# **Independent Audit Report**

**BLAKEBROOK QUARRY – MP07-0020**

Report Name: Independent Audit Report 05 - Blakebrook Quarry - MP07\_0020

Lismore City Council 43 Oliver Avenue Goonellabah NSW 2478

Figure 2: LPD 3 and existing water movement

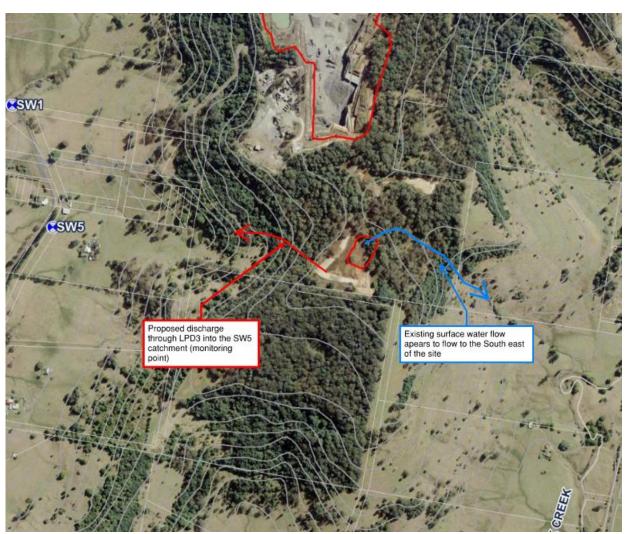
Or alternately investigate utilising a discharge point for the operation of the quarry to the east of the northern pit where the water currently runs (Figure 2). This may require an additional surface water monitoring point in Blakebrook Creek with additional verification relating to characterisation of this catchment. It is noted that this is currently being investigated for the site by LCC in regard to a suitable point for this purpose.

This eastern alternative from the southern pit has the advantage of utilising the terrain from the quarry to facilitate overtopping events following above design event rainfall and does not rely on significant pumping to facilitate this. If this is to be utilised a review of the quarry and footprint should be undertaken to ensure the operation of the quarry remains within the existing approved boundaries of the site.

It is recommended that the catchment to the east of the southern pit is investigated further for suitability given that the existing surface water flows from the site into that catchment to Blakebrook Creek.
